# CREDWELL

<b>Project</b>	469-483 Balmain Road Lilyfield
<b>Report</b>	Access Report
<b>Reference</b>	C220450-Access-r1
<b>Date</b>	12 May 2023
<b>Client</b>	Roche Group Pty Ltd
<b>Contact</b>	Andreas Brohl ABrohl@rochegroup.com.au

Figure 8 Non fire-isolated stair within Building D, Level 1

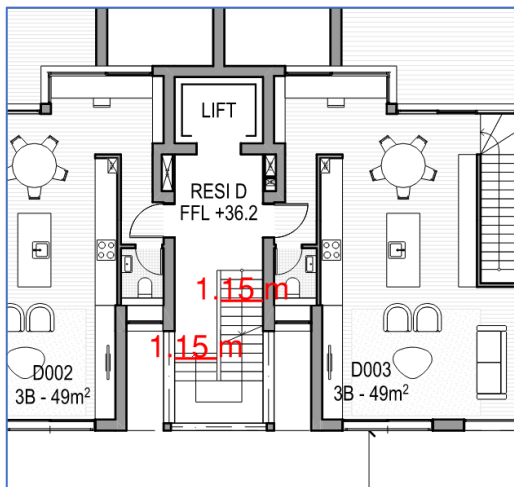
The non fire isolated stairways within Residential Building D, E, F must have double handrails complying with AS 1428.1 2009. The current configuration of the non fire-isolated stairways within Building D, E, F does not permit installation of compliant double handrails and 1m clear width path of travel between the handrails.

Accordingly, it is recommended that at the Construction Certificate Design stage that the stairways are provided with a minimum width of 1m (clear of handrails and any other obstructions).

Figure 11 Ground Floor

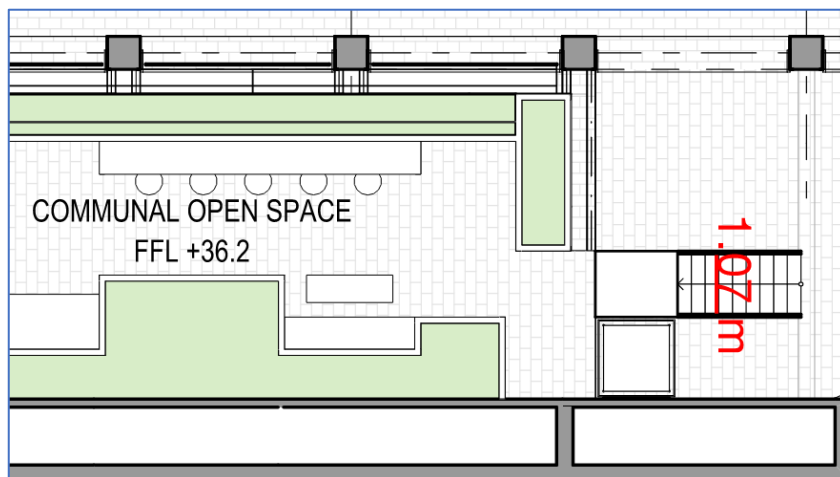
The current configuration of the stairway providing access to the communal area on the ground floor does not permit installation of compliant double handrails and 1m clear path of travel between the handrails.

Figure 12 Ground Floor

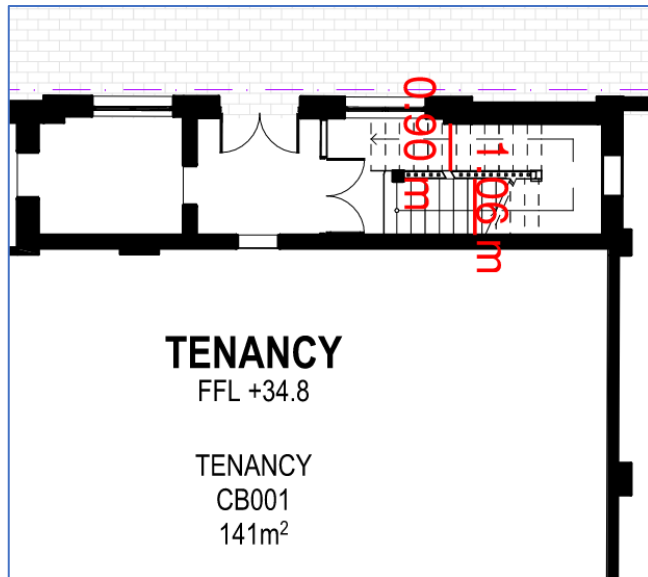
The current configuration of the stairway providing access to Tenancy CB11 on Balmain Road does not permit installation of compliant double handrails and 1m clear path of travel between the handrails.

Figure 14 Proposed ramp from the boundary on Alberto Street

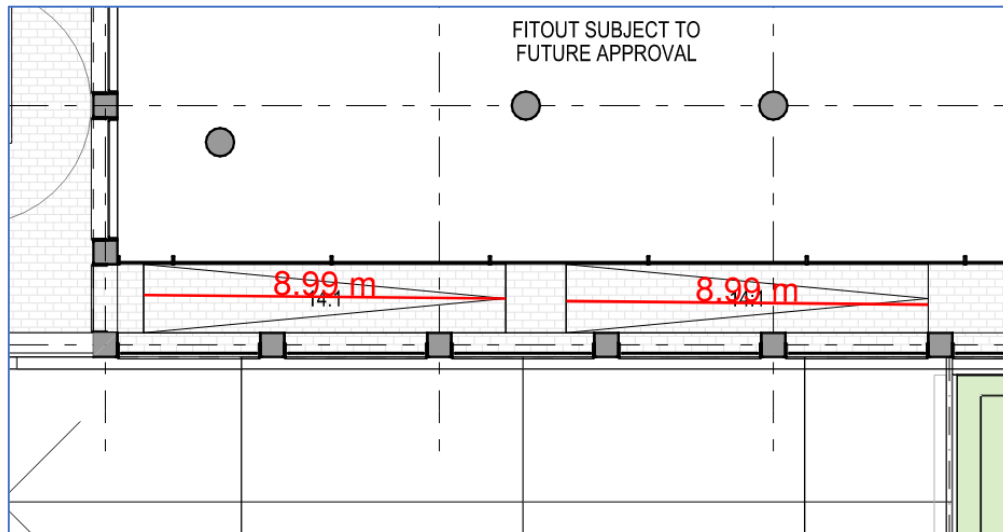
1:14 ramps are provided from the boundary on Albert Street. The ramp needs to have double handrails on both sides complying with AS 1428.1-2009.

Accordingly, it is recommended that at the Construction Certificate Design stage that the ramps are provided with compliant handrails.

Figure 15 Level 1 Podium

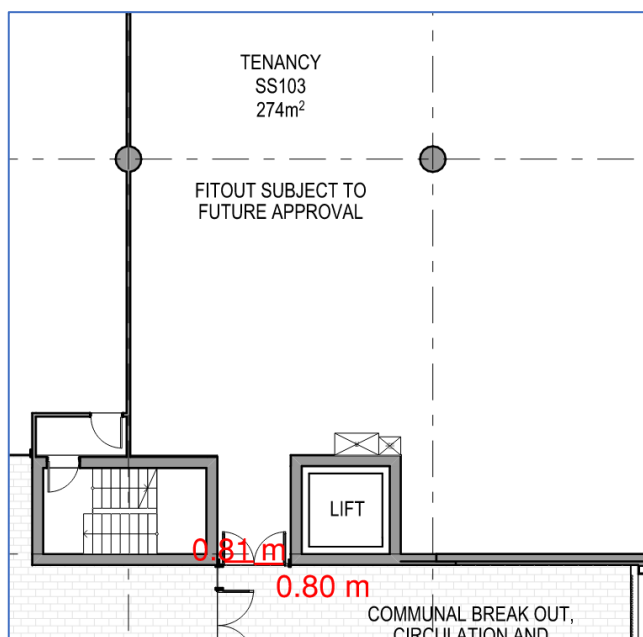
Doorways providing access to tenancy SS103 on Level 1 podium do not have 850mm clear width:

Accordingly, it is recommended that at the Construction Certificate Design stage that the doorways are provided with appropriate doorway circulation space.

Figure 16 Level 2

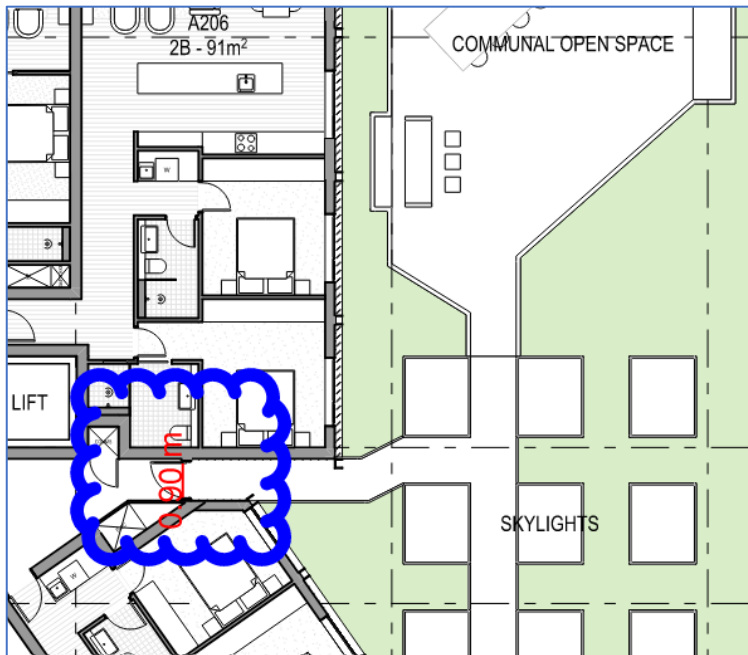
Doorway within Building A and Building B providing access to the communal open space on level 2 do not have required door circulation space:

Figure 18 Accessible toilet on Ground Floor

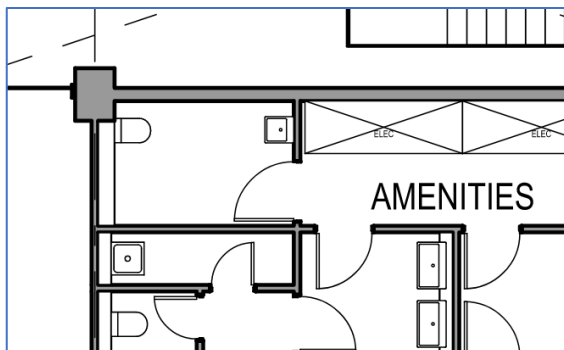
The accessible sanitary facility provided on the ground floor does not have 300mm clearance between swing of the doorway and the basin as required by AS 1428.1-2009:

Figure 20 Example: Entrance doorway to Unit B306 does not have clear opening width of 820mm

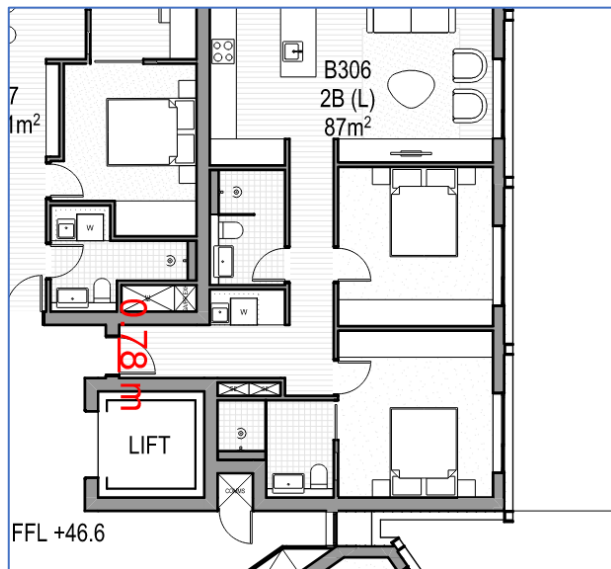
The entrance door to the livable units must have a minimum clear opening width of 820mm. Entrance to the livable units currently does not have a clear opening width of 820mm:

Figure 21 Example: Internal doorway within Unit B202 does not have clear opening width of 820mm

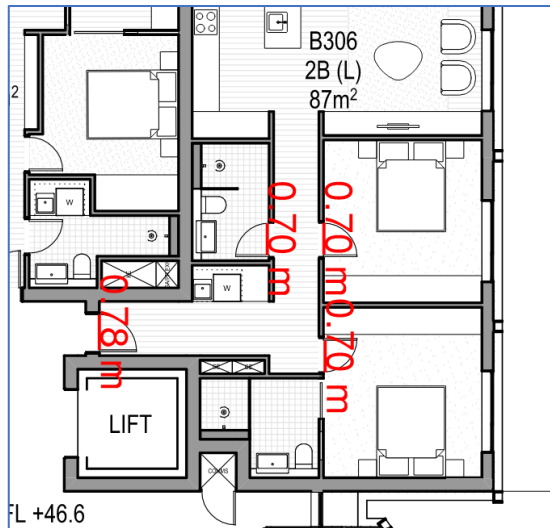
The internal doorways serving the living, dining, bedroom, bathroom, kitchen, laundry, and sanitary compartment must have a minimum clear opening width of 820mm. Internal doorways within livable units currently do not have a clear width of 820mm.

Figure 22 Example: Toilet within Unit A405 does not have 900mm between walls or obstructions

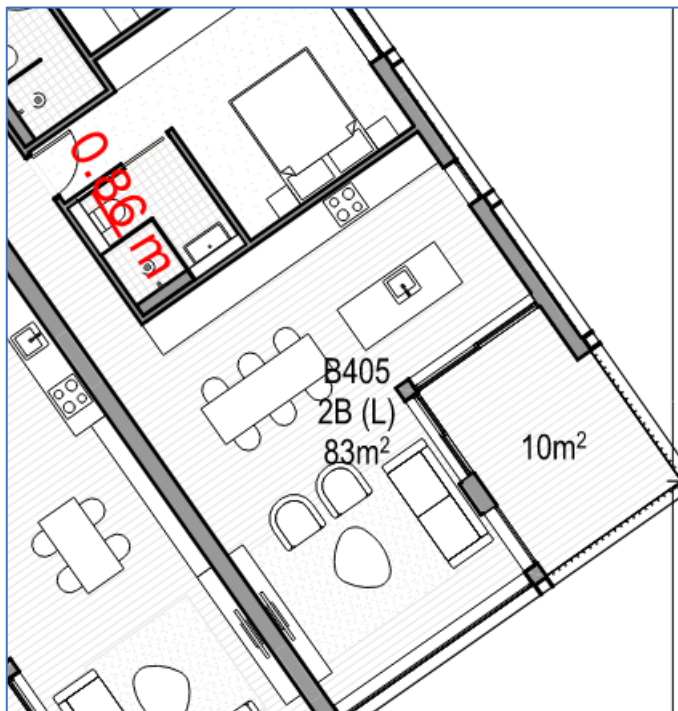
Currently the toilets within livable units do not have clear width of 900mm between the walls or obstructions and will need to be amended for construction stage.

Figure 23 Example: Toilet within Unit B302 does not have 1200mm forward the pan, exclusive of the door swing

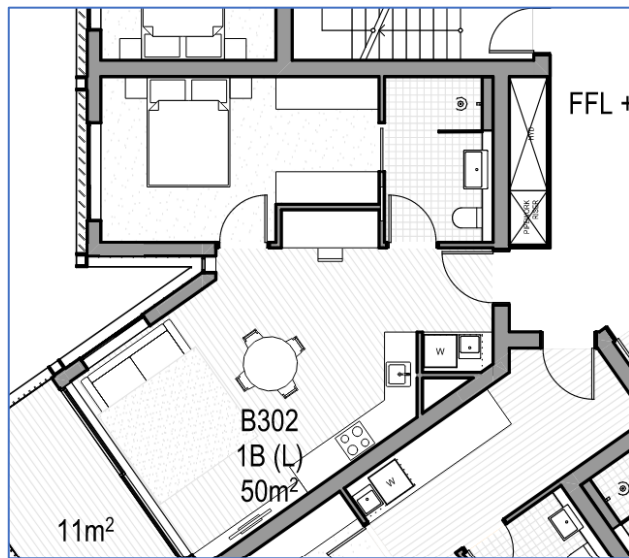
Currently the toilets within livable units do not have a minimum 1,200mm circulation forward of the pan, exclusive of the door swing and will need to be amended for construction stage.:

Figure 24 Example: Entrance doorway to Unit A202 does not have required door circulation

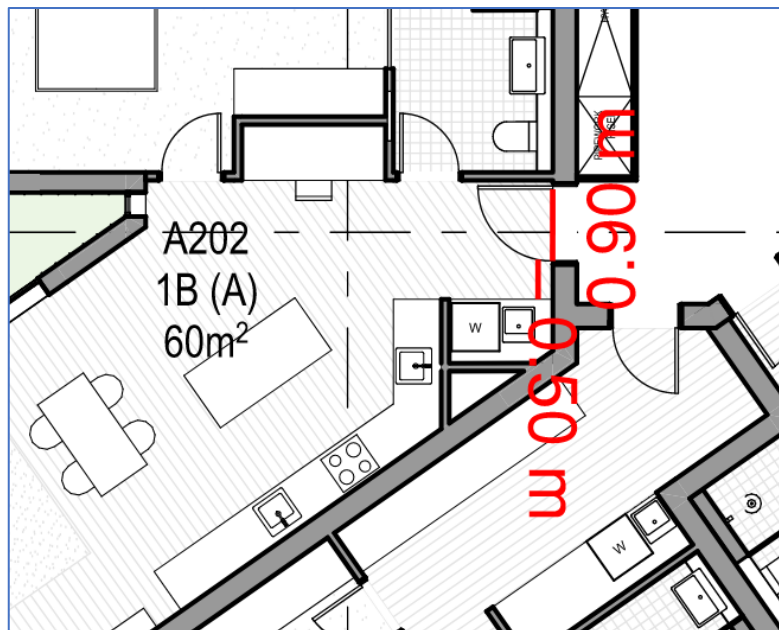
The entry doors adaptable units do not have required door circulation.

Figure 26 Example: Internal doorways within Unit A202 does not have clear width of 820mm

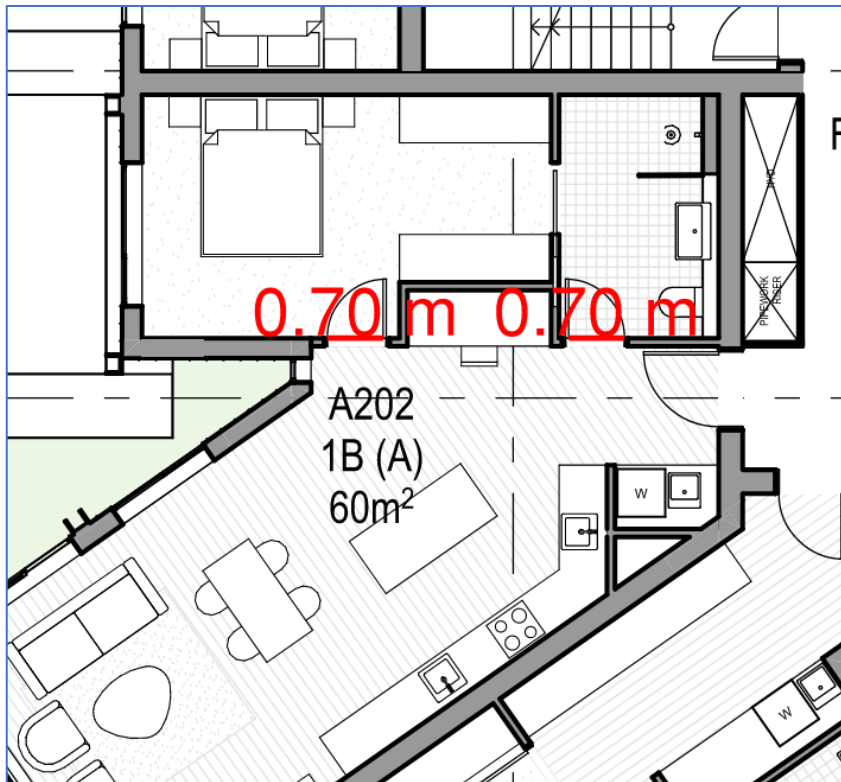
Currently the internal doorways within the adaptable units do not have clear width of 820mm.

Figure 27 Example: Toilet within Unit A303 does not have required circulation space

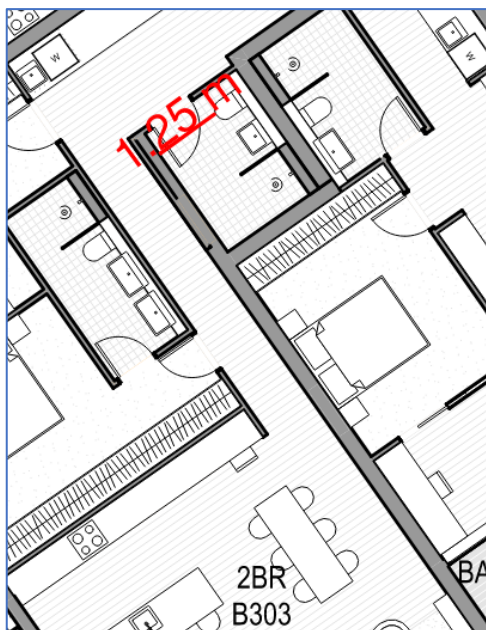
Currently the adaptable units do not have required circulation for an accessible toilet:

The bathroom area is to comply with clause 15 of AS1428.1-2009. To be indicated on a pre-adaption plan and shown as an accessible bathroom on a post adaption plan.

Figure 29 Example: Sanitary compartment showing overlap of washbasin fixture into shower circulation space

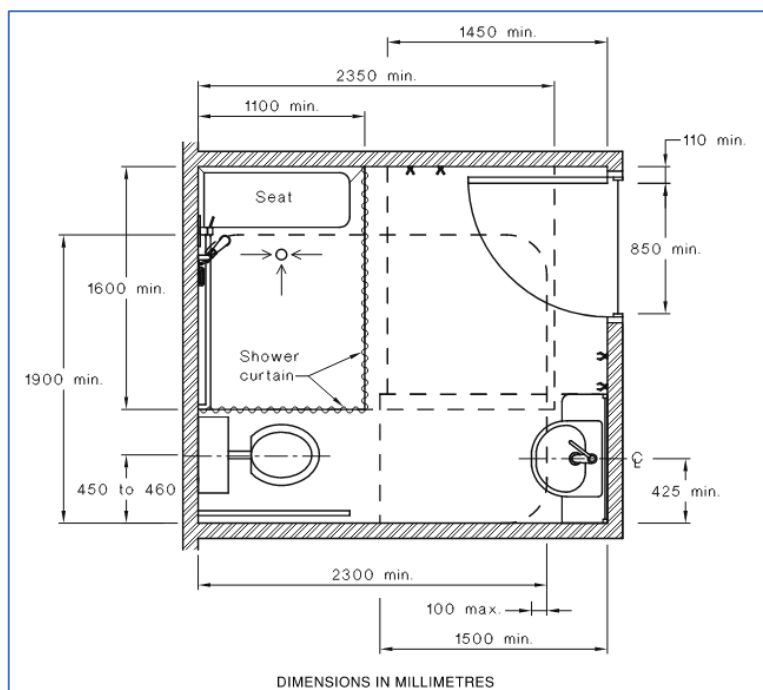
The pan within the adaptable units currently do not have correct distance from the wall.

Pan to be located correct distances from the walls in accordance with AS1428.1-2009 at pre adaption stage.

Figure 30 Example: Unit A202 does not have 1,550mm circulation in front of the laundry appliance

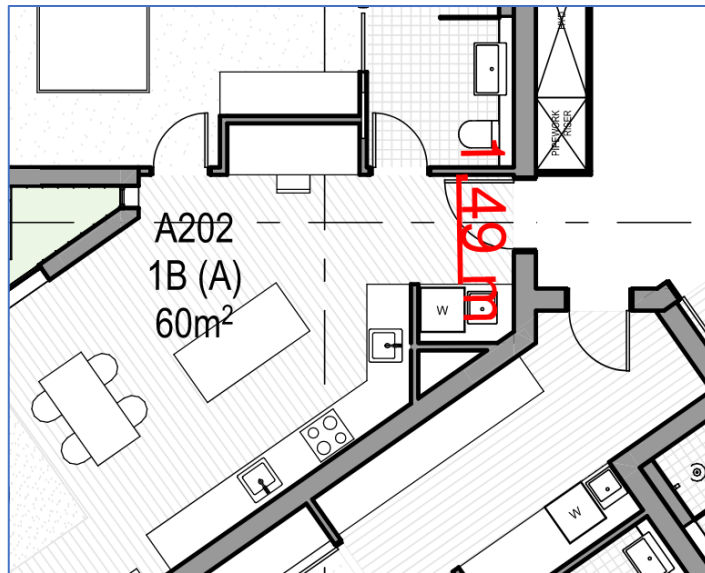
Currently 1,550mm circulation is not provided in front of the laundry appliances within adaptable units:

A minimum 1,550mm circulation space must be provided in front of the laundry appliances.
